This Service Program replaces bulletin, "Slack Adjuster Control Arm"
PV729-PI0767 (USA62644) dated (11/2013)

Slack Adjuster Control Arm
GU

PI0767, Slack Adjuster Control Arm

(April 2014)

W5080035

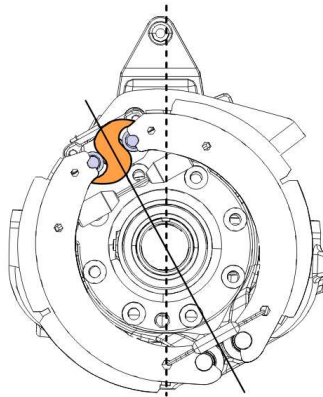
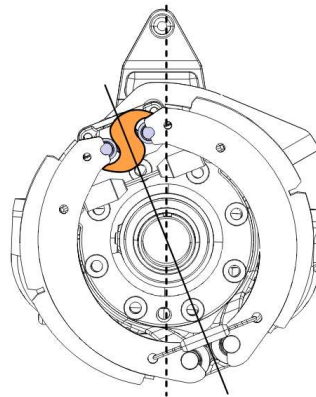
Certain GU model chassis' equipped with Haldex slack adjusters and Ridewell suspension with build dates between February 1 and March 24, 2010, may exhibit a condition which allows the slack adjuster control arm to make contact with the Ridewell suspension walking beam during steep suspension articulation. The articulation interference is possible only in the unloaded condition. A new brake package and slack adjuster are required to prevent this condition.

Old geometry

New geometry

- 9 Remove the spider hardware.
Note: Includes removing the wheel speed sensor and dust shield.
- 10 Remove the complete brake assembly.
- 11 Clean the mating surface of the axle and install the new brake assemblies (all parts and quantities, except seal) with all new spider hardware, and torque to 407 ± 41 Nm (300 ± 30 ft-lb).
Note: The new assemblies reorient the spider assembly rearward to provide sufficient clearance between the Slack adjuster control arm and the suspension walking beams.

W5080036

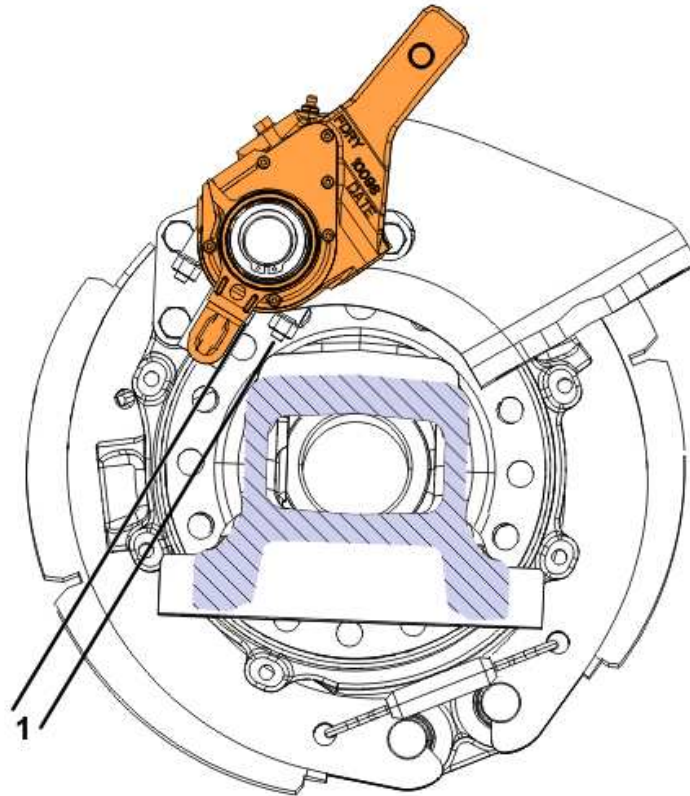
- 1 10–25 mm (0.39–0.98 in.) to axle housing

Rotate the slack adjuster's control arm bracket as needed to provide the orientation and clearance as illustrated. Tighten the control arm bracket U-bolt nuts to 27–41 Nm (20–30 ft-lb).
